- A. Carburetor Inlet Screen Removal
- B. Merc 1750 Fuel Pump Pulse Chamber
- C. New Alternator Driven Tachometer (C-79-76203A1)
- D. Timing Procedure - 1977 Merc 402
- E. Spark Plug Option - Merc 45-75-110

Figure 1.

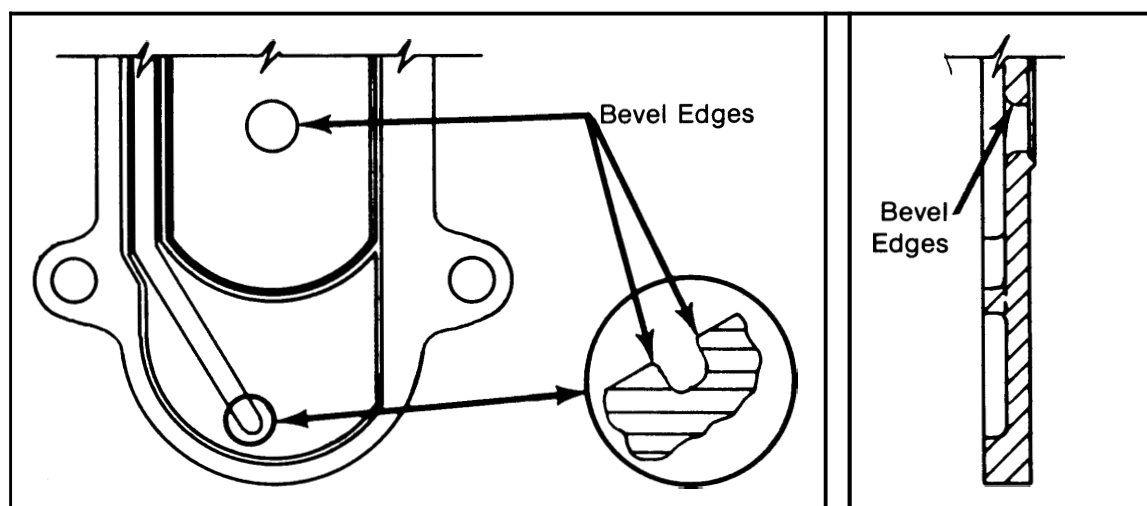
Occasionally, a diaphragm in a Merc 1750 fuel pump may split. Revisions have been made in the fuel pump pulse chamber (A-67622) to prevent this from happening. If fuel pump diaphragm splitting is experienced, however, bevel the edges of the slot and center hole, as shown in Figures 1 and 2.

Figure 3. Timing Location - Merc 402

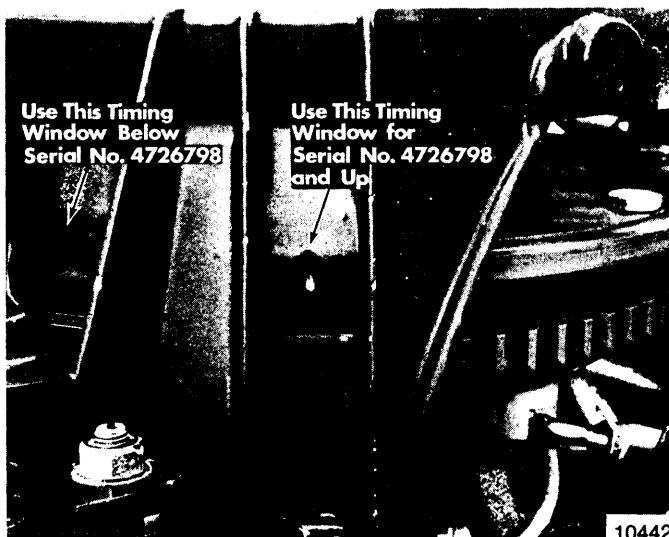
When following the "Timing/Synchronizing/Adjusting" procedure (in the Outboard Service Manual) on 1977 Merc 402, Serial No. 4726798 and up (those with removable top cowl), proceed with the instructions, except use the timing window on the right (when facing the outboard). (Figure 3) On Merc 402's below Serial No. 4726798, continue to use the timing window on the left (when facing the outboard).
